# Access Compliance Report

## Public Rights-of-Way

### (Curb Ramps)

Intersection ID: 18764	Main Street: RAMA_RD	Cross Street: SPRINGHOUSE_LN	Location: E
ADA ID: 0268BD5C4EF5	Ramp Type: PerpDiag	Initial Pass/Fail: Fail	Overall Compliance: No
		Severity Score: 25

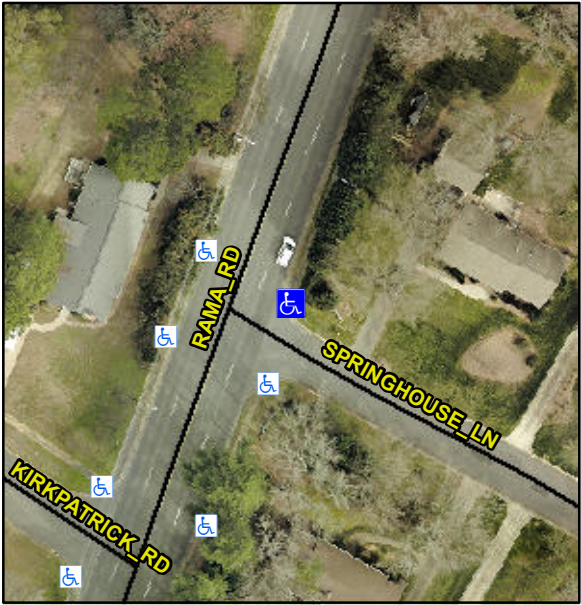
Codes/Mitigation Info/Possible Solution			Field Measurements/Component Compliance		
	Possible Solutions:		<b>Compliance</b>	<b>Description</b>	<b>Data</b>
	<b>Remove &amp; Replace Curb Ramp With Two New Directional Ramps or Equivalent.</b>		<b>No</b>	Ramp Length (in)	<b>60.0</b>
			<b>Yes</b>	Ramp Width (in)	<b>48.0</b>
			<b>N/A</b>	Flare Type LT	<b>N/A</b>
			<b>N/A</b>	Flare Slope LT (%)	<b>N/A</b>
			<b>N/A</b>	Flare Traversable LT?	<b>N/A</b>
			<b>N/A</b>	Landing Length (in)	<b>N/A</b>
			<b>N/A</b>	Landing Width (in)	<b>N/A</b>
			<b>N/A</b>	Landing Slope (%)	<b>N/A</b>
			<b>N/A</b>	Landing X Slope (%)	<b>N/A</b>
<p>Surveyor Notes:</p> <p><b>N/A</b></p>			<b>N/A</b>	Landing Curb? (Y/N)	<b>N/A</b>
			<b>N/A</b>	Shared Landing?	<b>N/A</b>
			<b>N/A</b>	Gutter Ponding?	<b>N/A</b>
			<b>N/A</b>	Gutter Lip Ht (in)	<b>N/A</b>
			<b>N/A</b>	Painted X Walk1?	<b>No</b>
				X Walk 1 Direction	<b>To NW</b>
			<b>N/A</b>	X Walk 1 Width (in)	<b>N/A</b>

X Walk 1 Slope (%)	<b>3.9</b>
				X Walk 1 X Slope (%)	<b>0.3</b>
			<b>N/A</b>	Ramp inside XWalk1?	<b>N/A</b>
<p>PROW/ADA:</p> <p><b>Not Found, R304.2.2, R304.5.3</b></p>			<b>N/A</b>	Road Slope (%)	<b>3.0</b>
				Road X Slope (%)	<b>3.4</b>
			<b>N/A</b>	Any Obstructions?	<b>N/A</b>
				Obstruction Type	
			<b>N/A</b>		<b>N/A</b>
			<b>Yes</b>	Surface Condition? (G/P)	<b>Good</b>
Total Cost:		\$ 3200.00
